HBN 4 En-suite bathroom mock up

Summary of feedback from Open Days

Doors

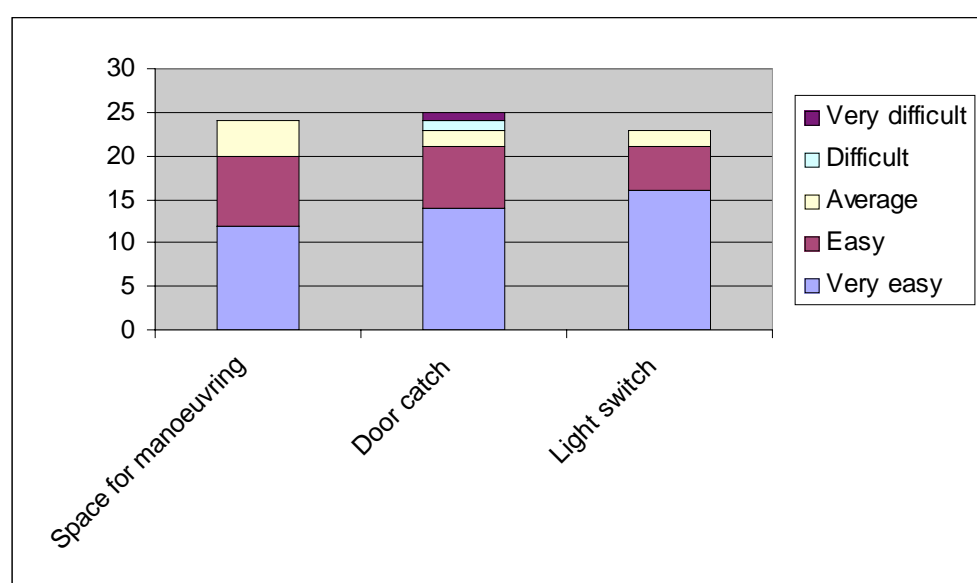
Generally, visitors felt the door was very easy to manoeuvre and that the overall design ensured the patient's privacy and dignity. The track mechanism at the top of the door was liked. People commented on the need for good quality doors that would withstand heavy use/bumps from equipment etc.

Some patients might think pull cords are light switches. Could light come on automatically when door is opened? This would avoid confusion.

A grab rail on the door adjacent to the WC pan would be useful for ease of closing for independent wheelchair users.

The bolting mechanism for the large door needs careful consideration – it needs to be easily operated by independent wheelchair users.

WC

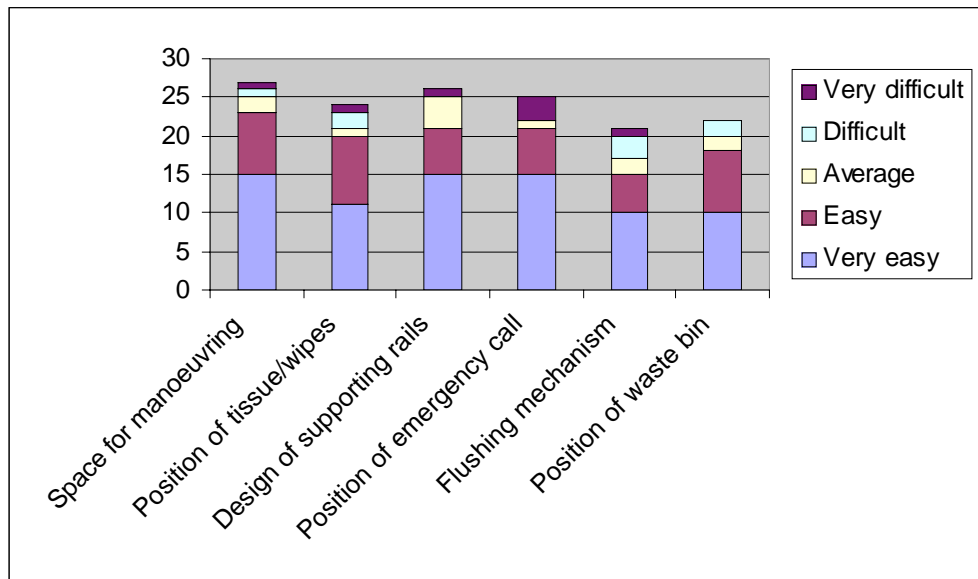
Height adjustable WCs would be useful for some patients eg, those with arthritic joints, women post-caesarian etc.

Emergency pull cord needs to be further forward, as patients cannot see them or stretch their arms back that far.

Waste bin – a push lid will get very dirty. Needs to be non touch. Mobile waste bin would be more useful.

Flushing mechanism should be an electric sensor/non touch.

Wash basin

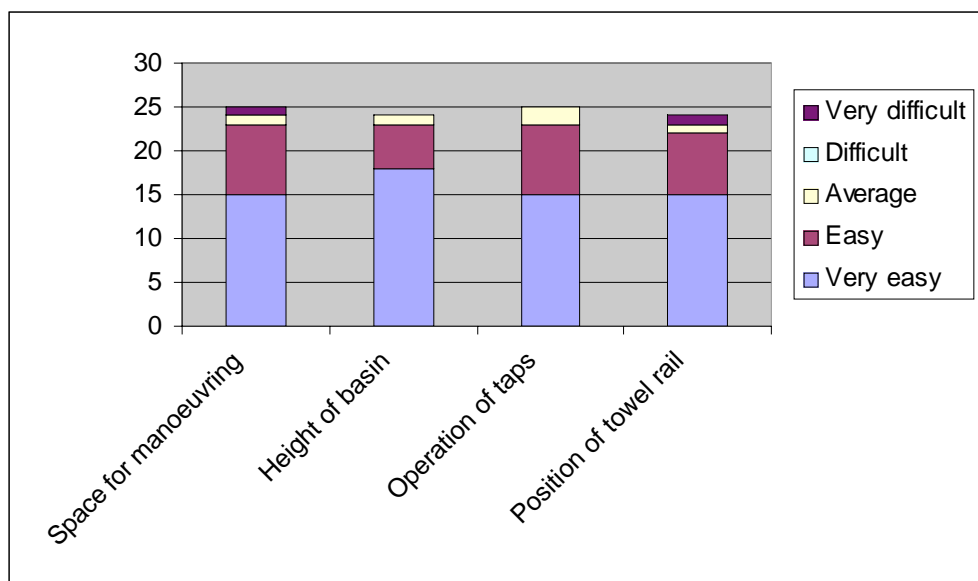
Back support behind WC – is this in line with infection control?

Difficult to access tissues/wipes when grab rail is down.

More space required between WC and door.

Wall mounted WC pan preferred by some visitors.

Taps should be sensor operated, and should have longer lever. Shaver light switch too high.

Height adjustable sink very popular amongst nursing staff. Healthcare planners concerned about the expense of this equipment – extra cost allowance?

One visitor commented that the chamfered layout compromises space around the wash basin.

Shower

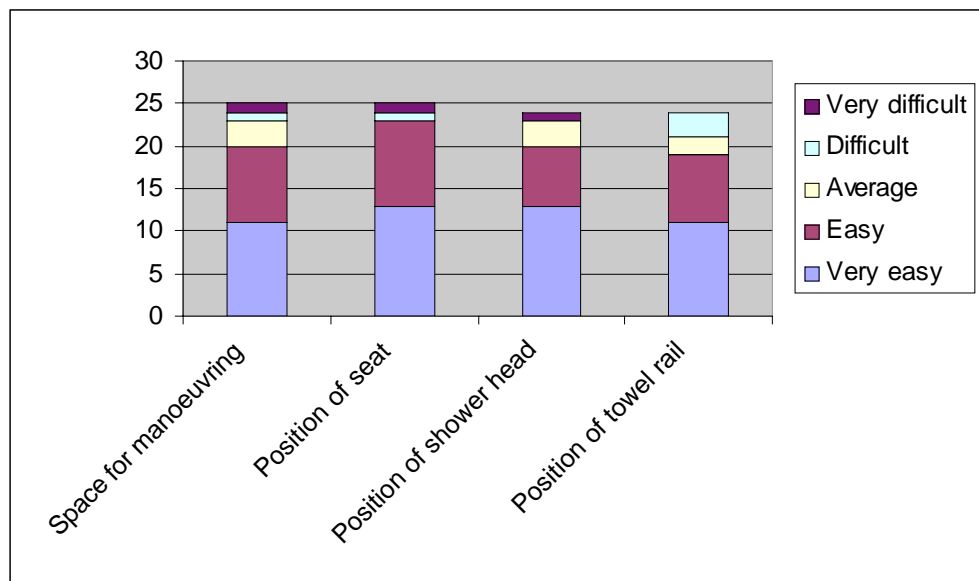
The size of the room effectively makes the en-suite a 'wet' area – probably constitutes an increased risk (slip hazard) to patients. Rectangular layout preferred to chamfered layout in this respect. General concerns about drainage/slope of the floor.

Shower seat should have aperture for staff to wash patients from underneath. Towel rail can't be reached while sitting on the shower seat.

Some patients might find it difficult to turn around to reach the shower head while sitting on the seat.

Horizontal grab rail on wall required.

Emergency pull cord for shower seems to be in the way of access – should be moved back.

Adjustable shower

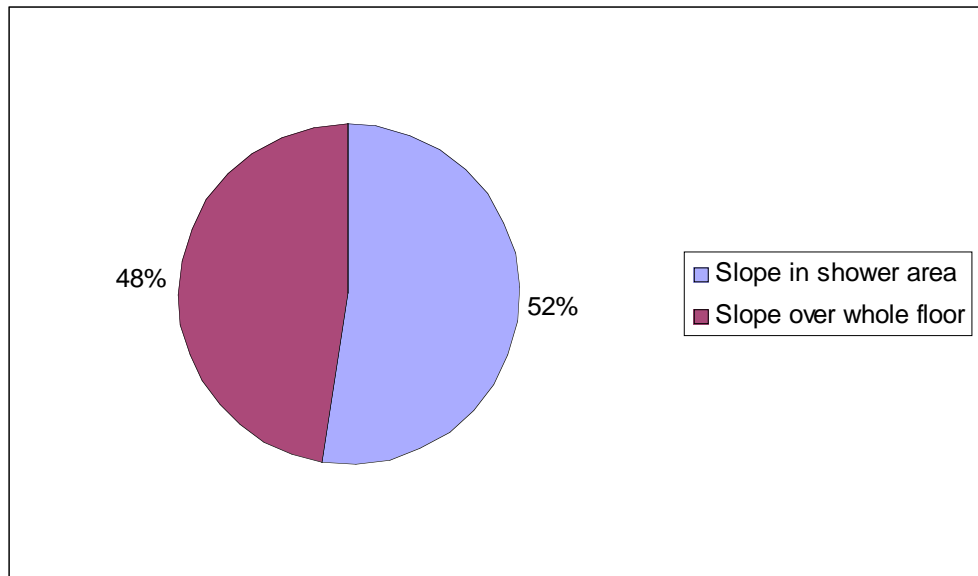
Generally liked. Many people felt that patients would like to sit during a shower, especially on stroke, elderly and rehab wards.

Some nurses commented that they were more likely to transfer patients to a shower chair rather than onto a shower seat.

Important to be able to reach patient from both sides in case of cardiac arrest.
Arm rests need to move vertically with the seat.

Slope over entire floor prevents puddles outside the shower area. Also makes it easier to clean. Potentially disorientating, though, for patients who are unsteady on their feet.

Splashing across the whole bathroom is unavoidable – measures required to prevent water spilling out into bedroom.

Fixtures

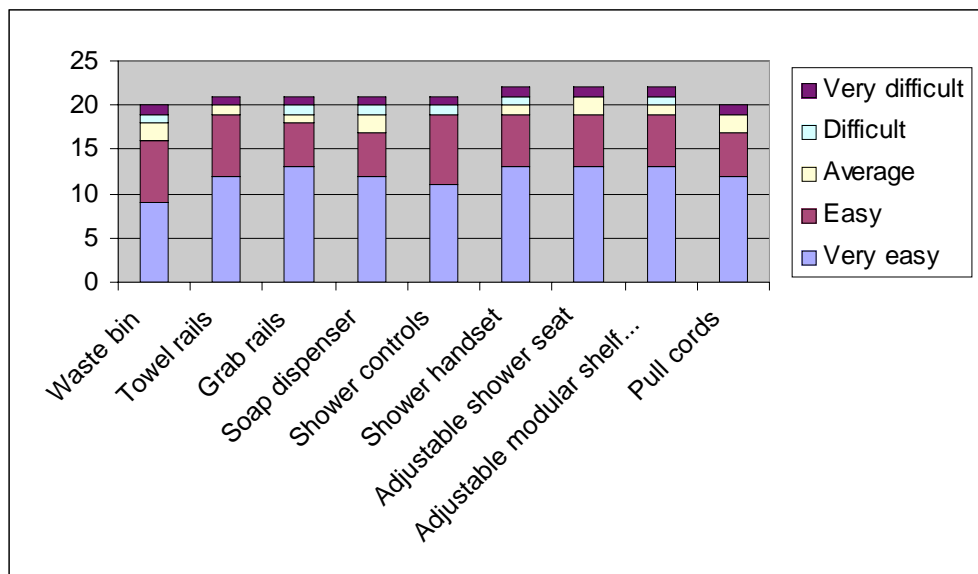
Pull cords not far enough forwards to see or use. Others commented that they would get in the way of hoists and other equipment.

Waste bin should be larger and non-touch design.
Plug access for resus trolley must be near to en-suite.
